**Public Input No. 30-NFPA 99-2024 [Global Input]**

First Revision No. 971-NFPA 99-2021 [Section No. 1.3.2.3]

Figure 1

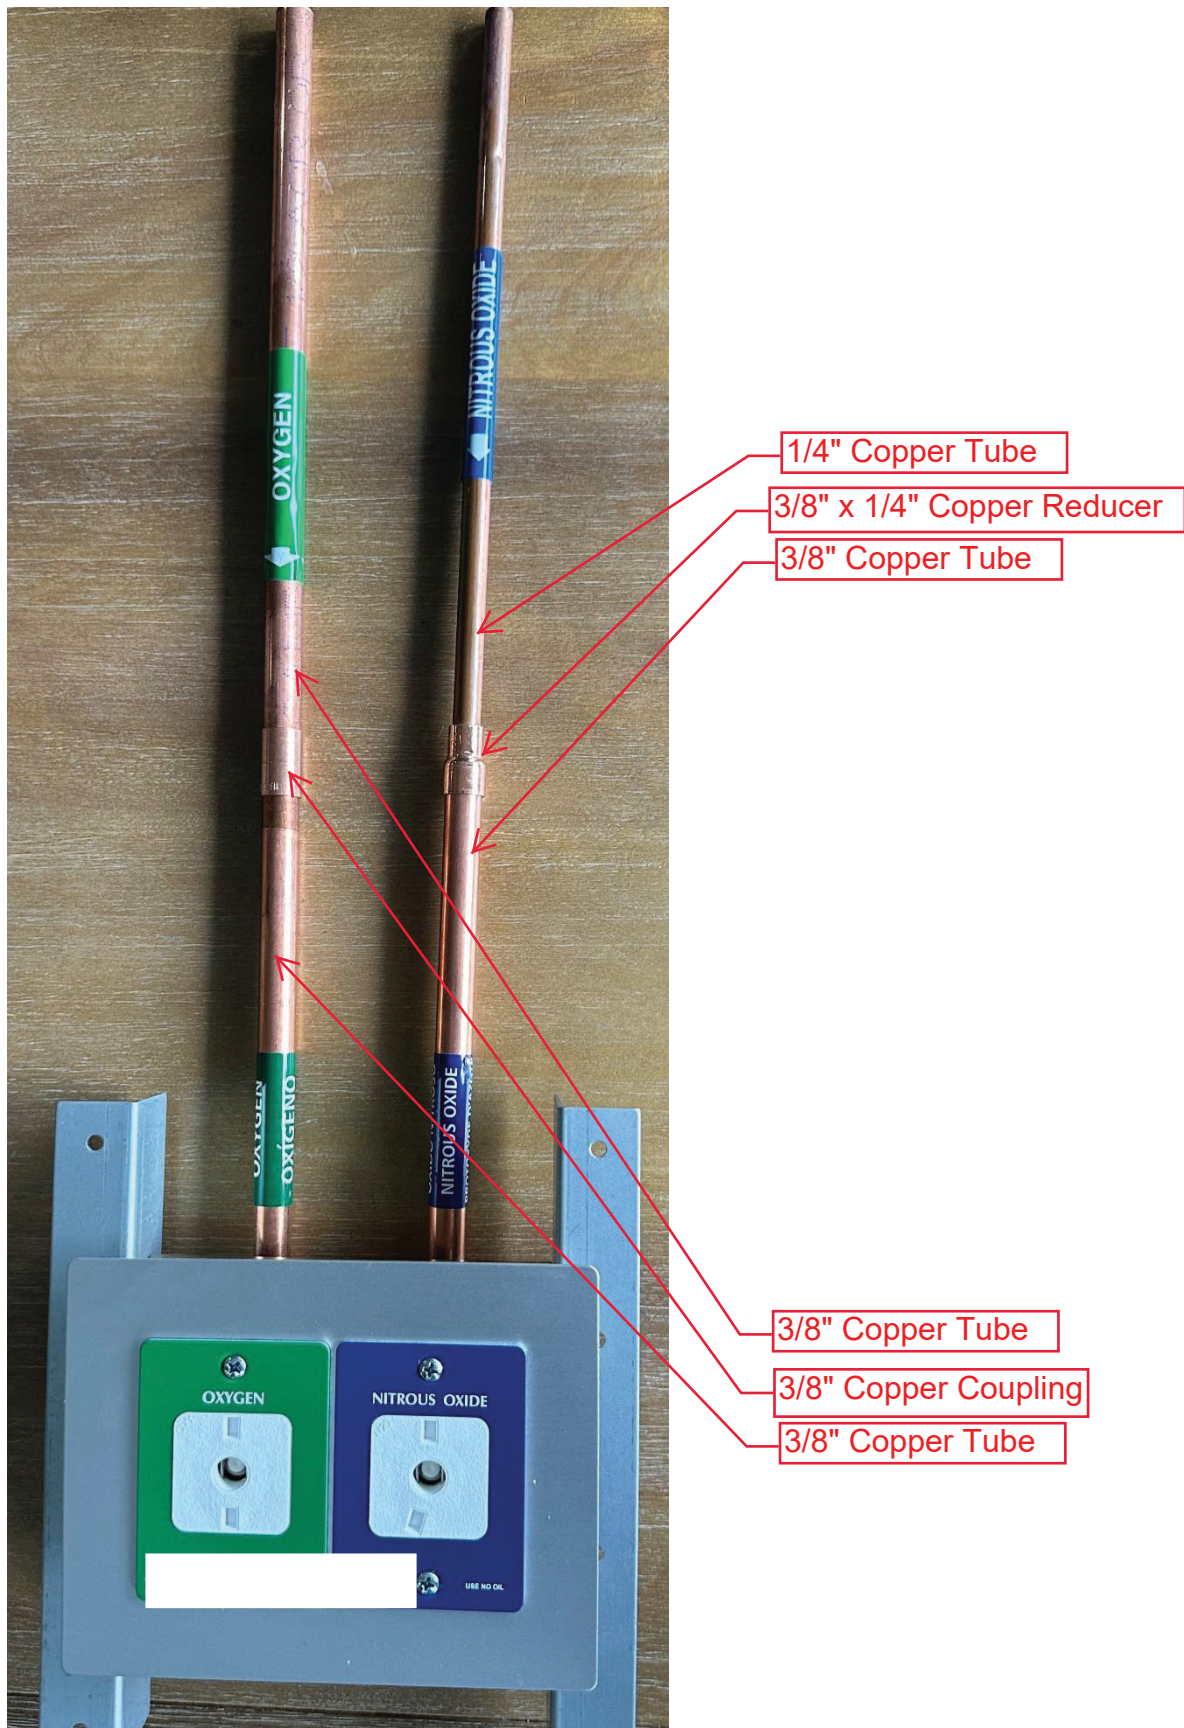
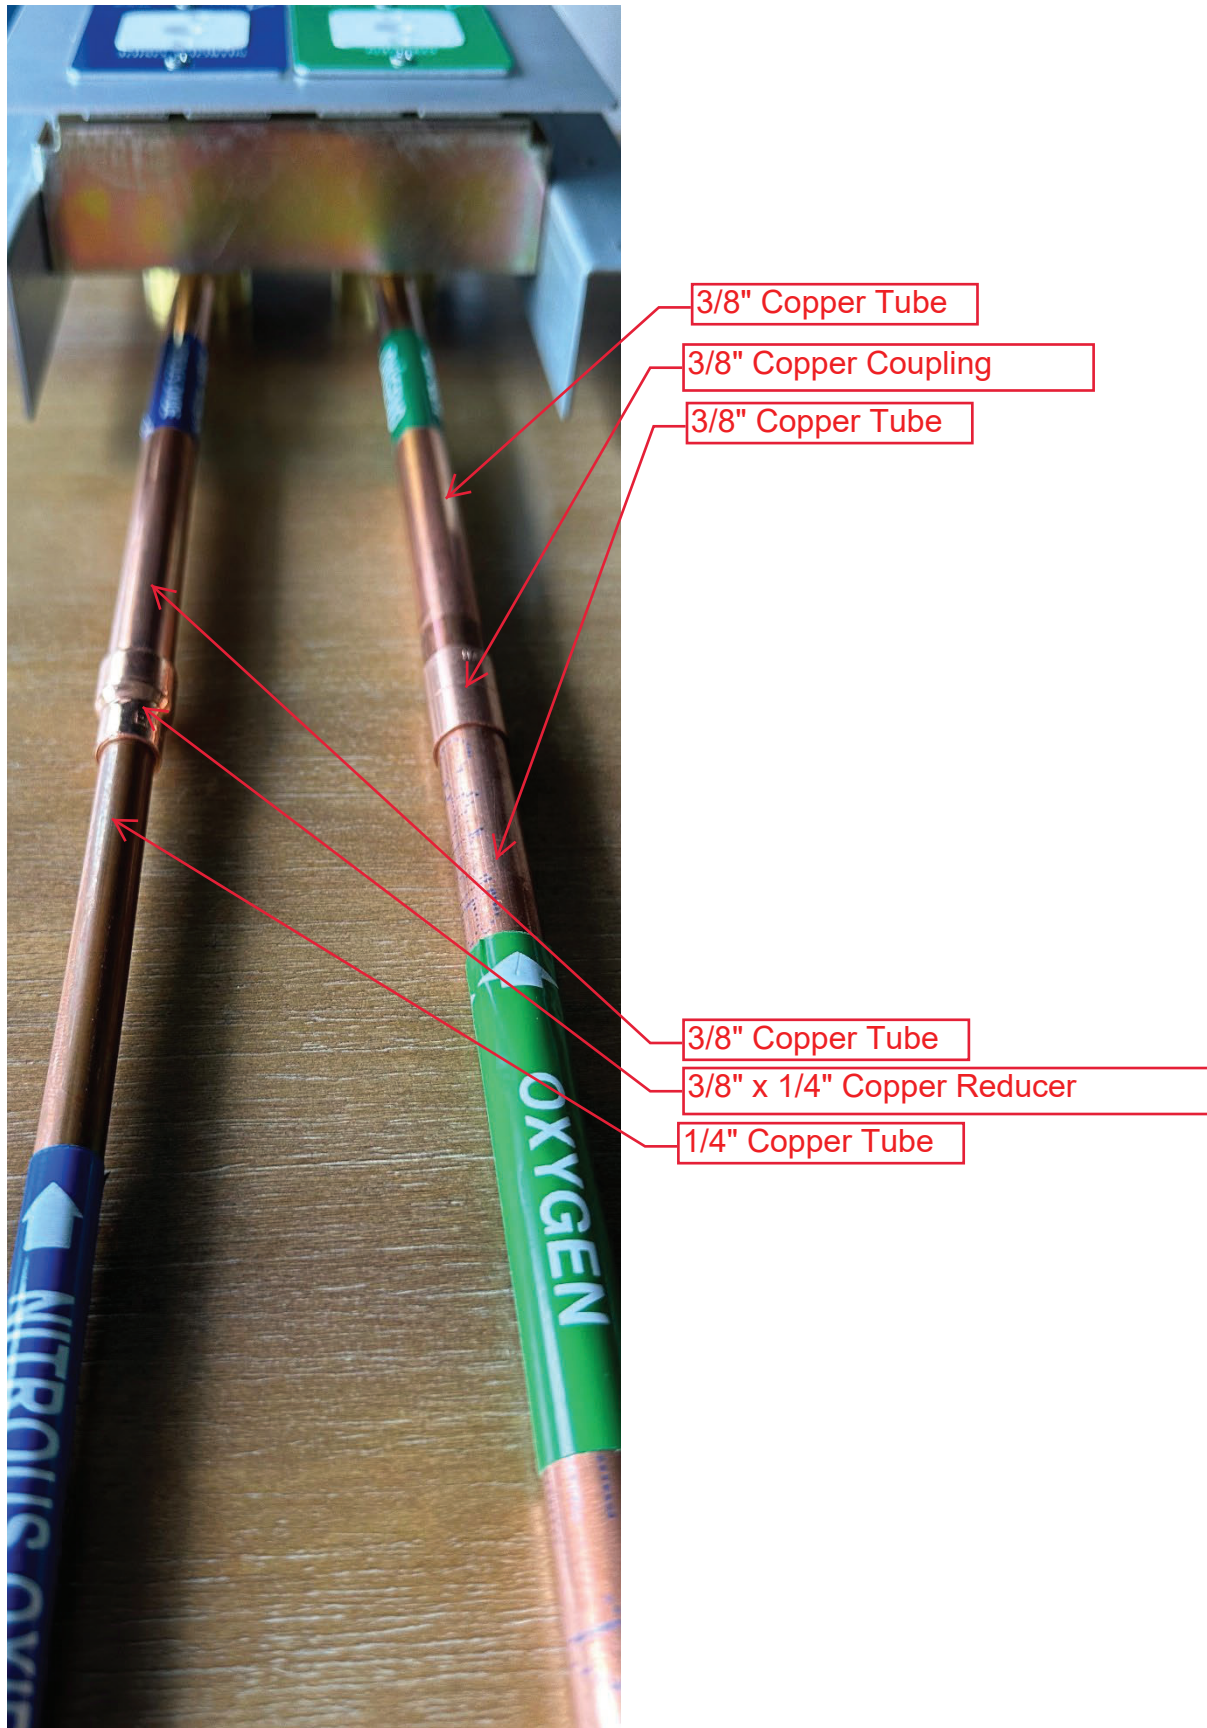
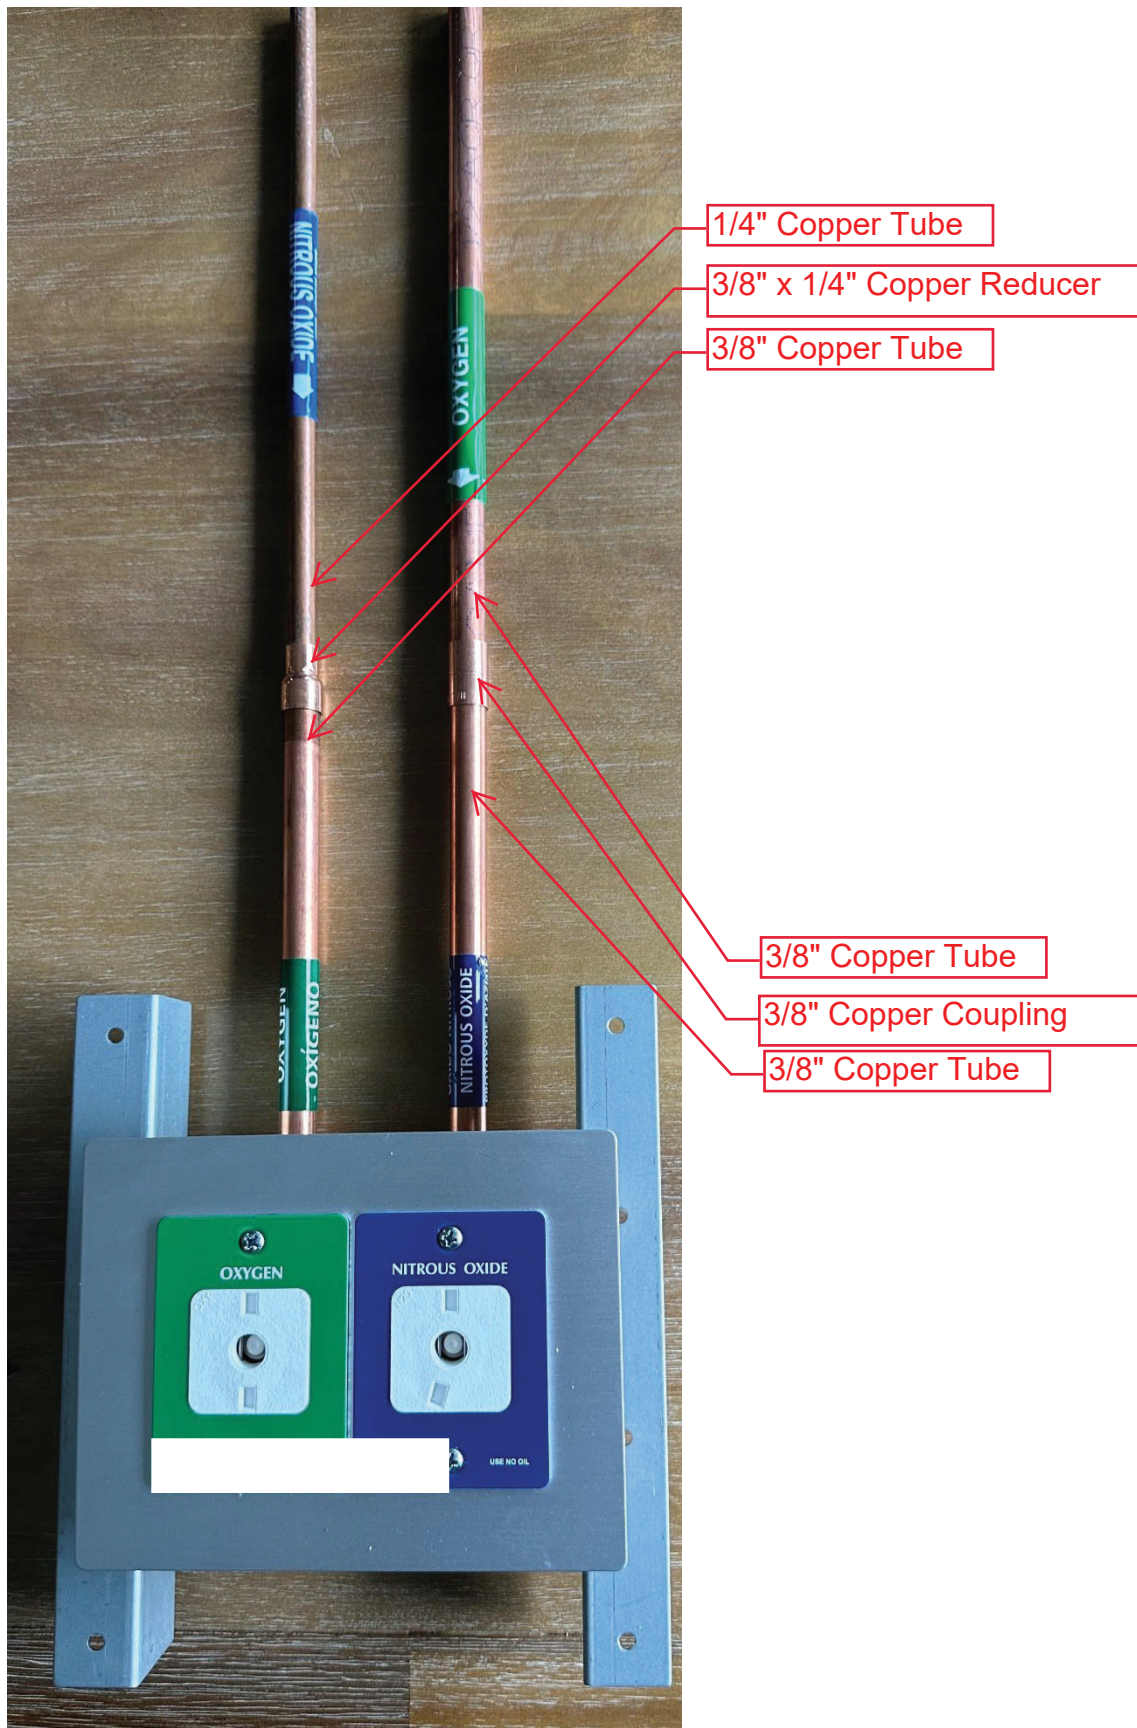
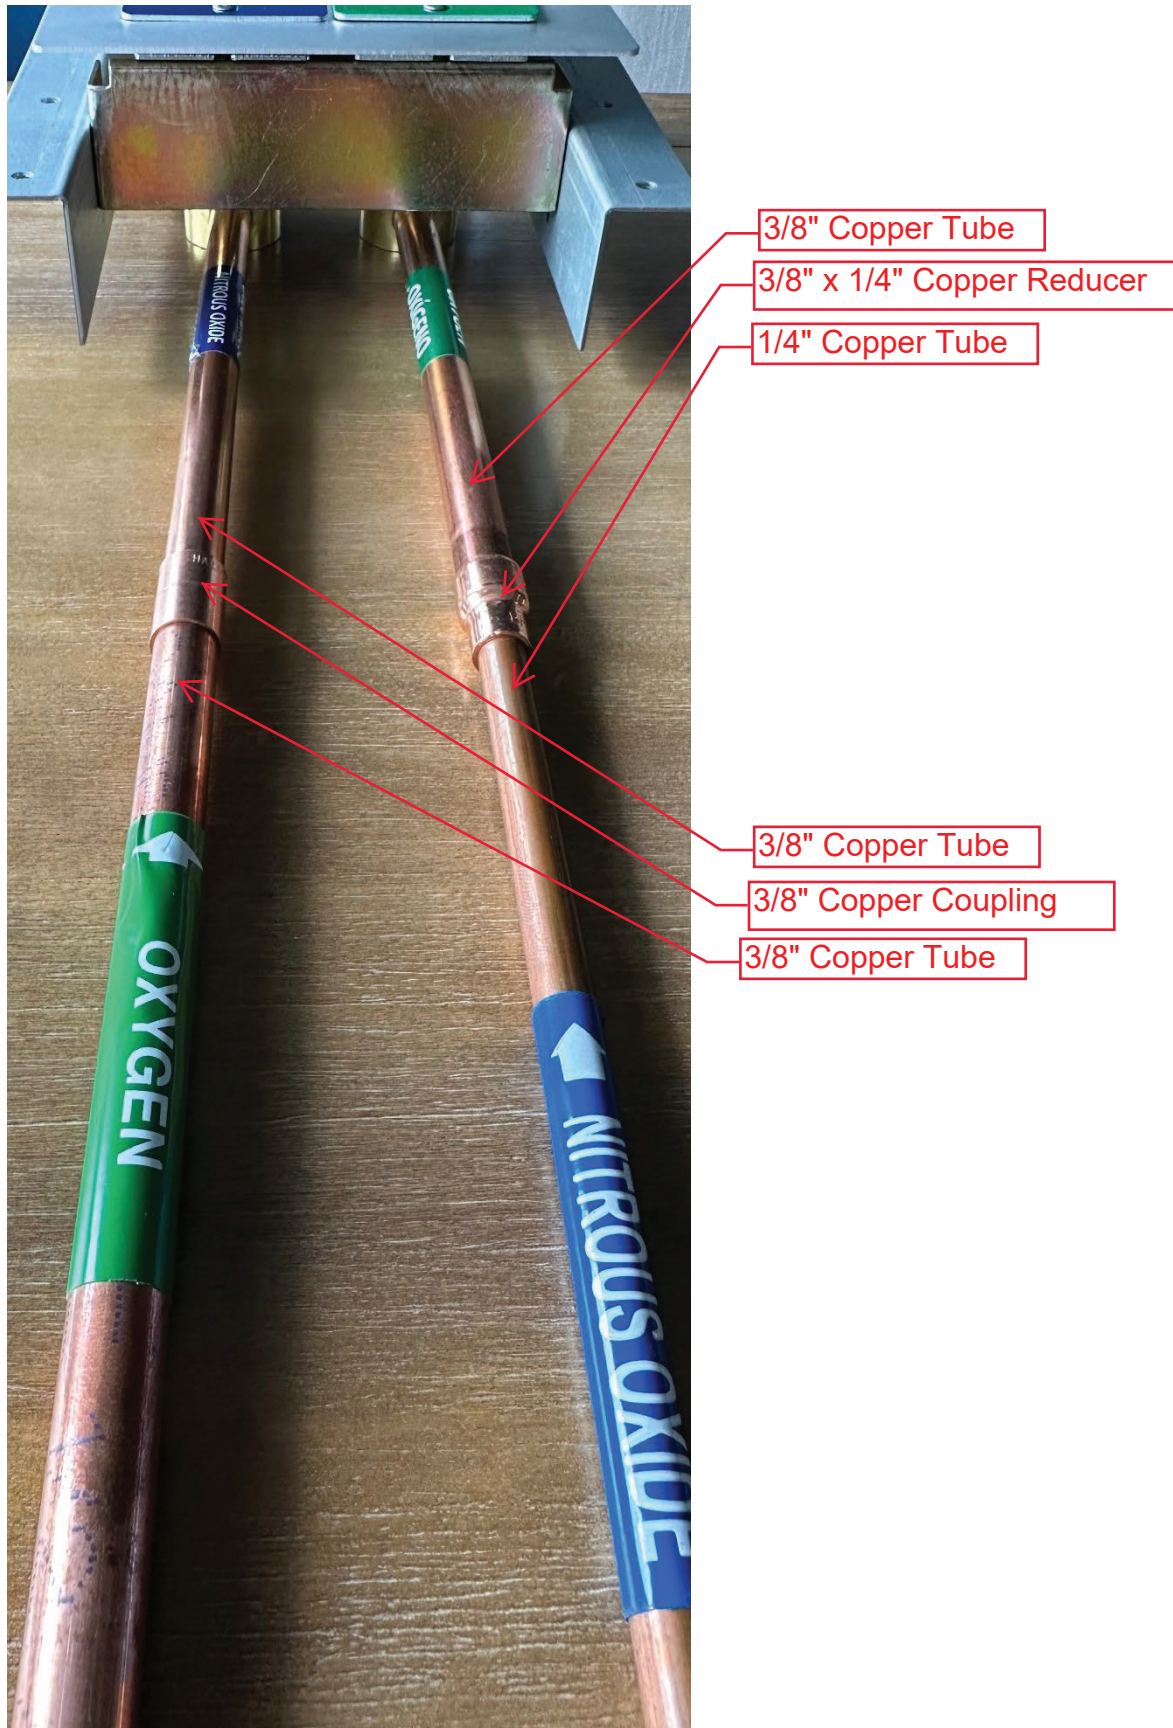
cross connection prevention tactic will ultimately lead to those same individuals skipping or not doing as complete of a job in their testing, verifying, and commissioning process such as the cross-connection tests that are already required. There will be groups that simply skip the required tests because they have depended on the two different sizes catching any problems.

Requiring the two different pipe sizes is done under the assumption that Oxygen will be 3/8" NPS tube and Nitrous 1/4" NPS tube. That assumption comes from the way that some dental equipment suppliers have supplied their equipment such as outlets in the past. While many small clinics can use the minimum required pipe sizes to meet flow requirements, this is not always the case. In most larger offices (more than 3-4 chairs) it is highly likely that the pipe sizes will be increased from the minimum required. More and more large-scale offices are being built where the minimum pipe sizes are not large enough and larger pipe sizes are being used. For example, a larger system requiring a 3/4" NPS Nitrous Oxide Line when properly sized, the code would now require that the Oxygen be increased to 1" NPS, even if a 3/4" NPS Oxygen line would meet the engineering and flow requirements. This would add additional construction costs and exceeds a "minimum standard".
